TECHNICAL BULLETIN
JTB00507NAS1
15 JUL 2016

SECTION: 417-01

Hood May Contact Headlamp(s)

XF (X250)

E193784

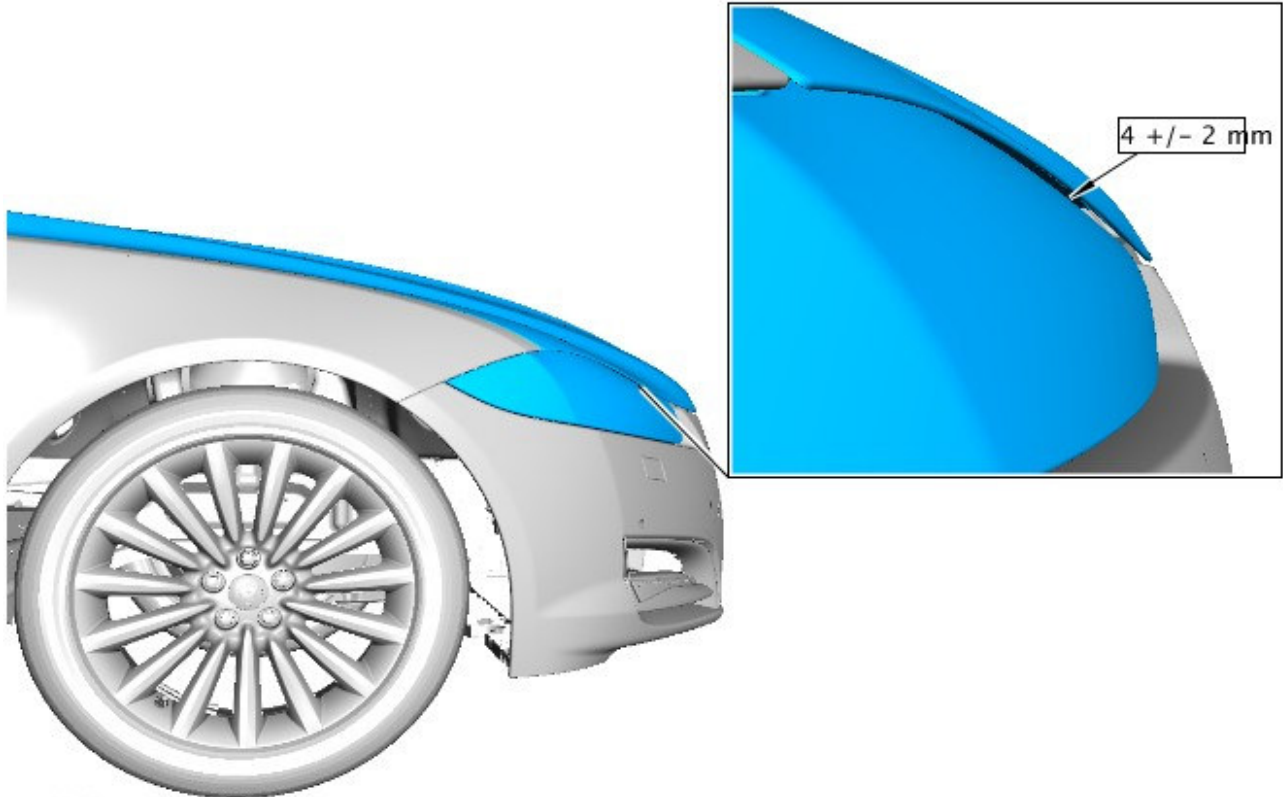
1.  **NOTE: Gap specification: $4 \pm 2\text{mm}$.**

Using a suitable tool, measure the headlamp-to-hood gap.

- If the headlamp-to-hood gaps are not within specification ($4 \pm 2\text{mm}$), continue to Step 2
- If the headlamp-to-hood gaps are within specification ($4 \pm 2\text{mm}$), this is not the cause of the customer concern. Do not continue with this Technical Bulletin.

E193519

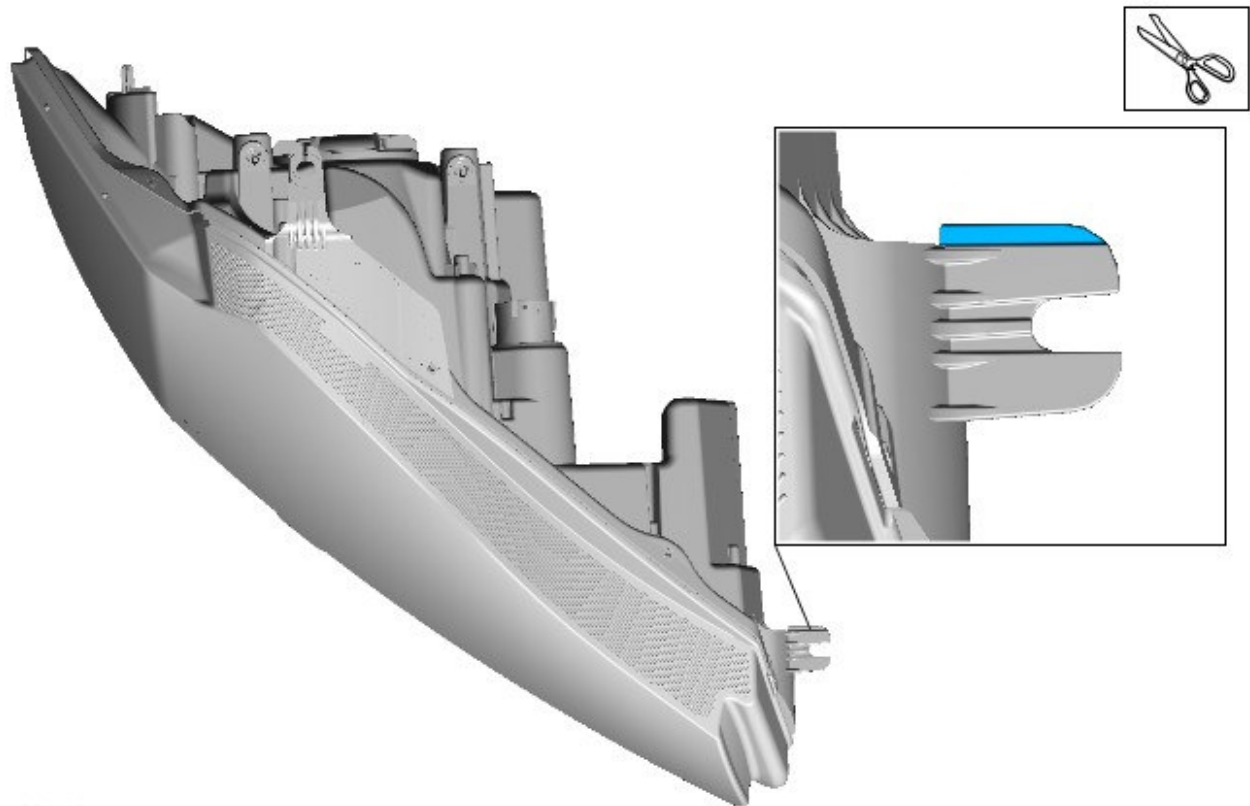
5.  **NOTE: Right hand-lamp shown; left-hand lamp similar.**

Trim the tab off the new headlamp(s) before installation as shown.

E193784

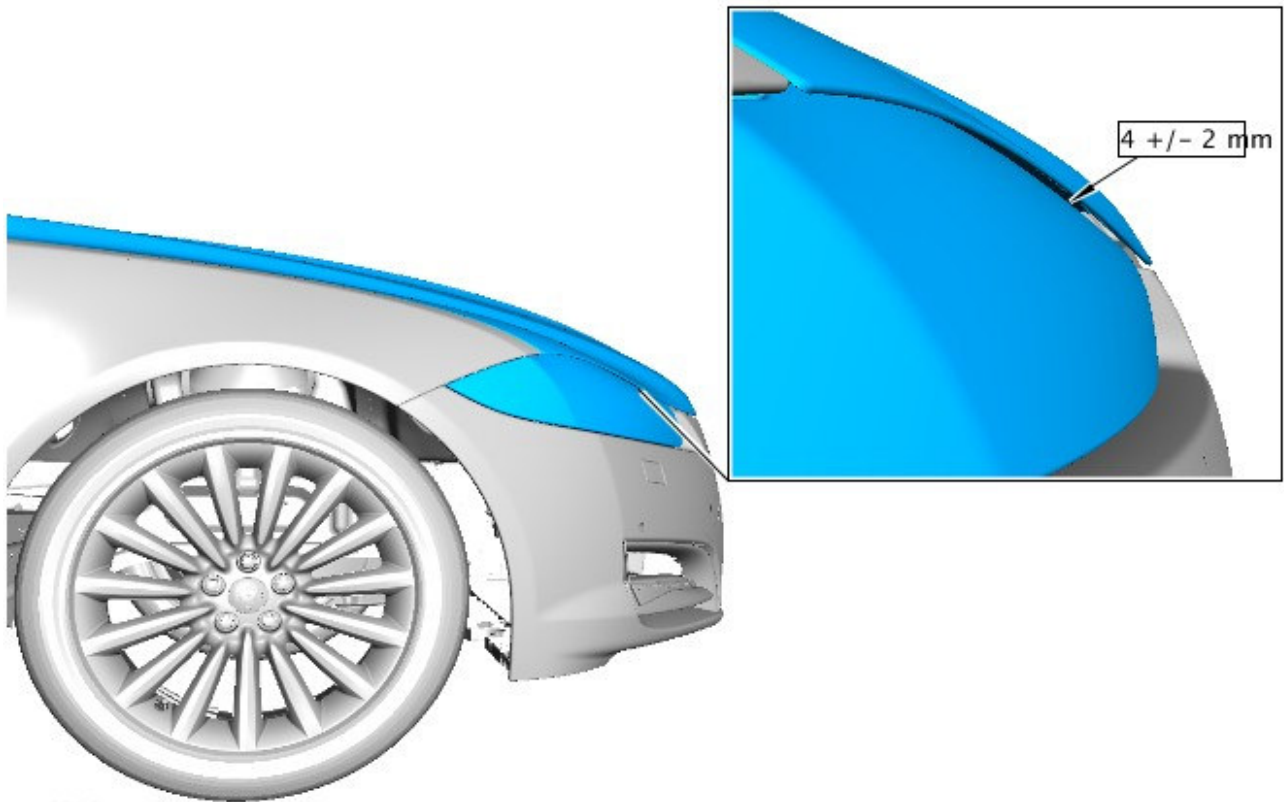
7.  **NOTE: Gap specification: $4 \pm 2\text{mm}$.**

Using a suitable tool, measure the headlamp-to-hood gap.

- If the headlamp-to-hood gaps are not within specification ($4 \pm 2\text{mm}$), continue to Step 8.
- If the headlamp-to-hood gaps are within specification ($4 \pm 2\text{mm}$), continue to Step 10.
